DETROIT ECONOMIC GROWTH ASSOCIATION  
JOE LOUIS GREENWAY WARREN YARD TRAILHEAD CONSTRUCTION PROJECT  
ADDENDUM NO. 3  
January 12, 2022

## **Exhibit 1 – Supplemental Information for Bidders**

## Exhibit 3 – Site Drawings

PIP PLAYGROUND SURFACING AND EDGE

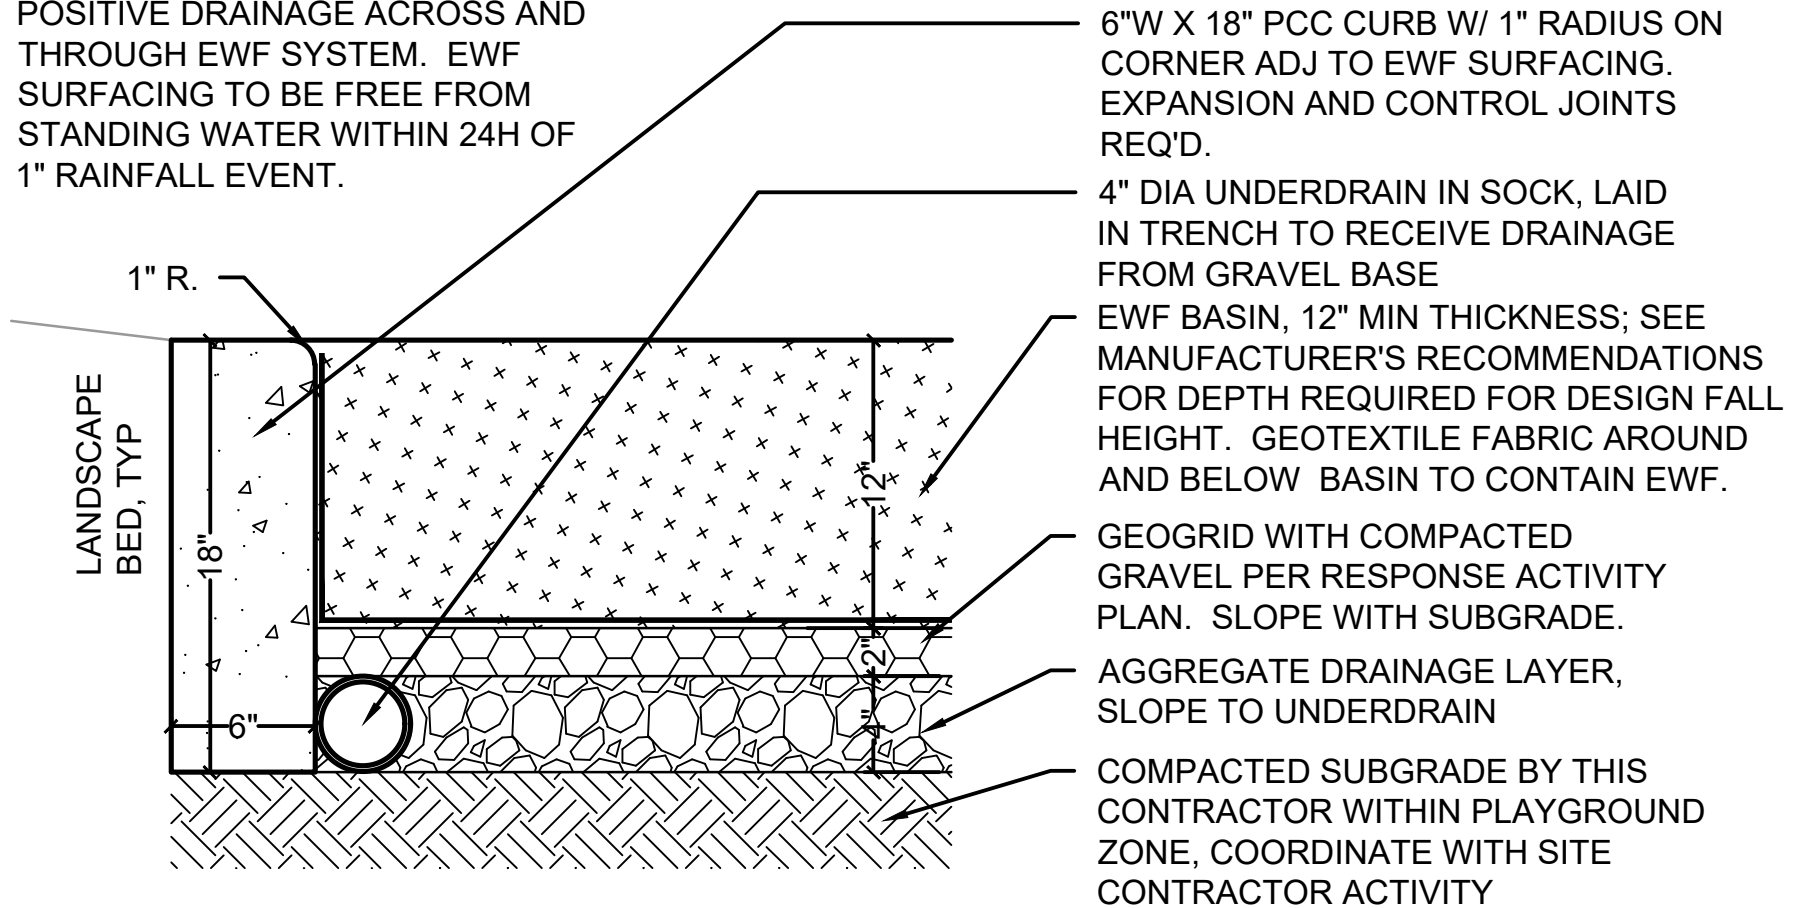
NOTE: SHOP DRAWINGS AND ENGINEER'S CERTIFICATE REQUIRED FOR PIP SURFACING. CONTRACTOR TO REVIEW FALL HEIGHT REQUIREMENTS, PROPOSED EQUIPMENT, AND EQUIPMENT FALL ZONES, AND ACCOUNT FOR THE SAME IN PROPOSED SURFACING SYSTEM. CONTRACTOR TO FOLLOW MANUFACTURER'S RECOMMENDATION FOR PIP SYSTEM AND ITS INSTALLATION, UNDER OBSERVATION AND CONFIRMATION BY CONTRACTOR'S CPSI PROFESSIONAL

NOTE: CONTRACTOR TO ENSURE POSITIVE DRAINAGE ACROSS AND THROUGH PIP SYSTEM. PIP SURFACING TO BE FREE FROM STANDING WATER WITHIN 24H OF 1" RAINFALL EVENT.

EWF PLAYGROUND SURFACING AND EDGE

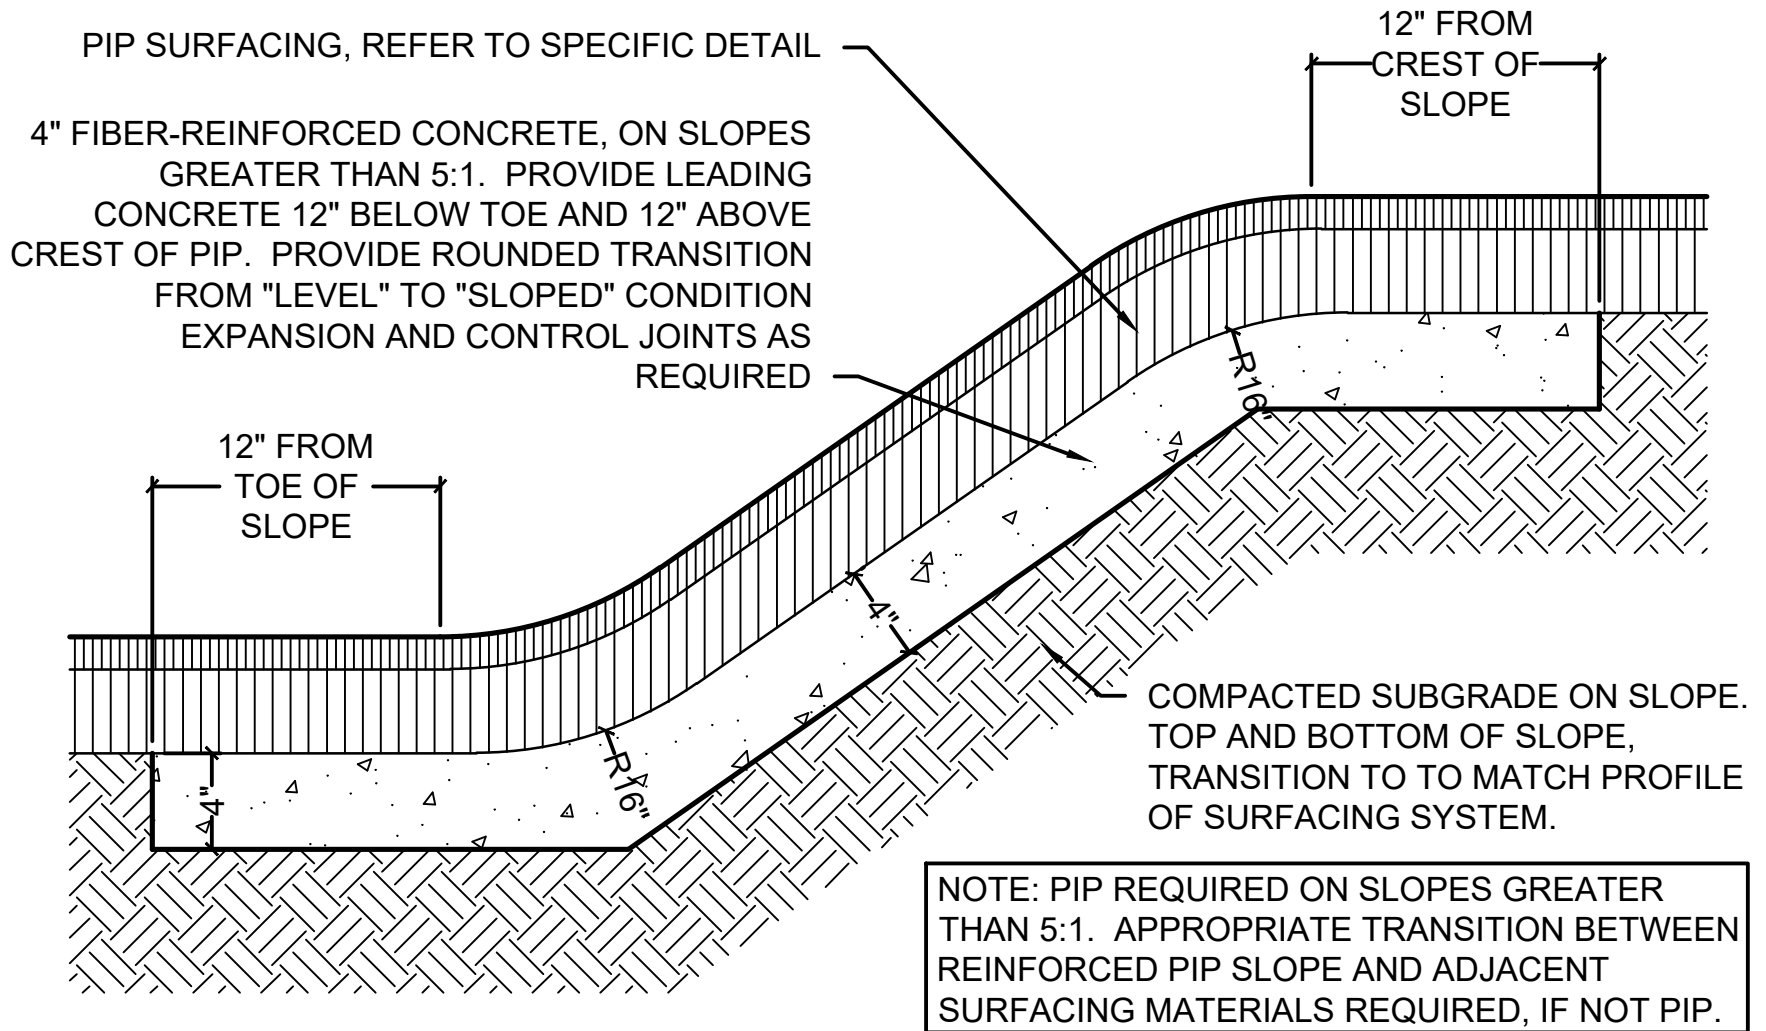
NOTE: SHOP DRAWINGS AND ENGINEER'S CERTIFICATE REQUIRED FOR EWF SURFACING. CONTRACTOR TO REVIEW FALL HEIGHT REQUIREMENTS, PROPOSED EQUIPMENT, AND EQUIPMENT FALL ZONES, AND ACCOUNT FOR THE SAME IN PROPOSED SURFACING SYSTEM. CONTRACTOR TO FOLLOW MANUFACTURER'S RECOMMENDATION FOR EWF SYSTEM AND ITS INSTALLATION, UNDER OBSERVATION AND CONFIRMATION BY CONTRACTOR'S CPSI PROFESSIONAL

NOTE: CONTRACTOR TO ENSURE POSITIVE DRAINAGE ACROSS AND THROUGH EWF SYSTEM. EWF SURFACING TO BE FREE FROM STANDING WATER WITHIN 24H OF 1" RAINFALL EVENT.

SUPPLEMENTAL DRAWING  
**JOE LOUIS GREENWAY 1E - PLAYGROUND**  
EXHIBIT 1A - DRAINAGE CONCEPT AND UTILITIES

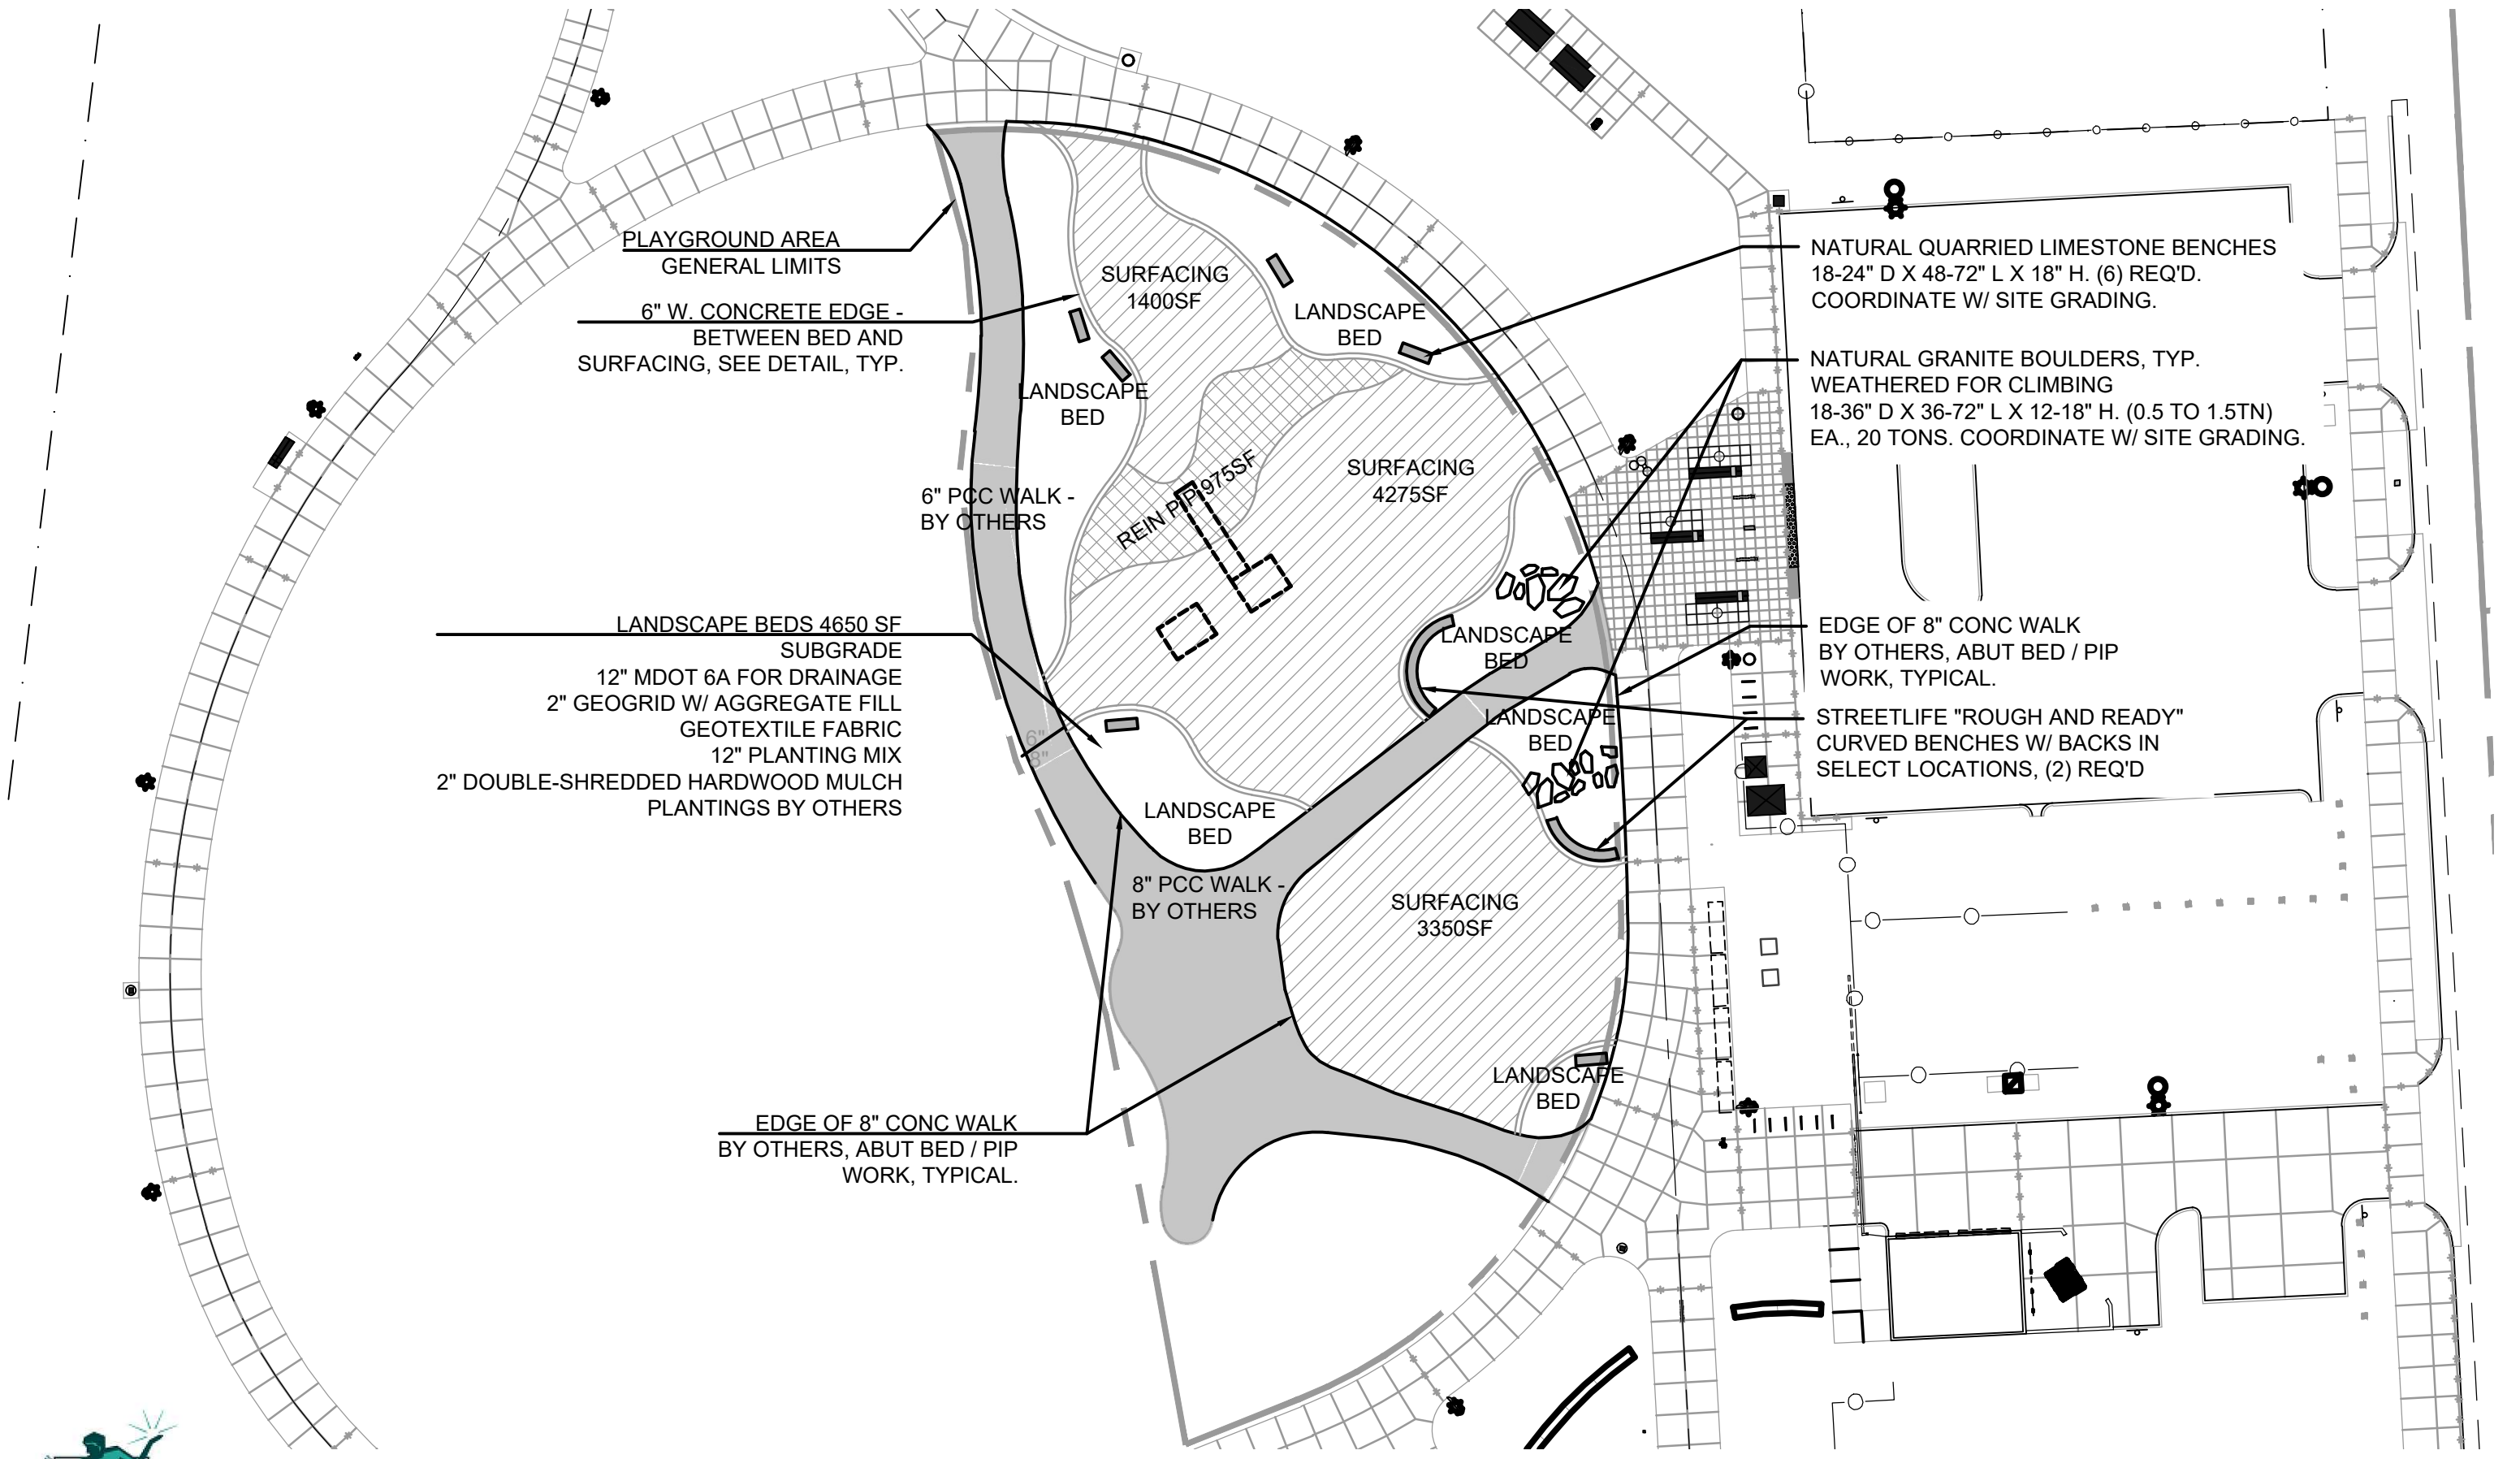
COORDINATE W/ SITE WORK  
ADDED 2" CONDUIT FOR  
(2) LIGHT POLES BY OTHERS

12" RCP - COORDINATE  
W/ SITE CONTRACTOR AS WORK  
RELATES TO PLAYGROUND

48" BASIN BY OTHERS  
COORDINATE W/  
SITE CONTRACTOR

CLEANOUT FOR  
UNDERDRAIN, TYP

4" UNDERDRAIN  
BENEATH SURFACE, TYP.  
MIN SLOPE 0.5%  
FIELD LOCATE AROUND  
EQUIPMENT FOOTINGS

48" MANHOLE AND STRUCTURE BY  
OTHERS, INSIDE LANDSCAPE BED

12" RCP 80LF  
BY OTHERS

12" RCP 115LF  
BY OTHERS
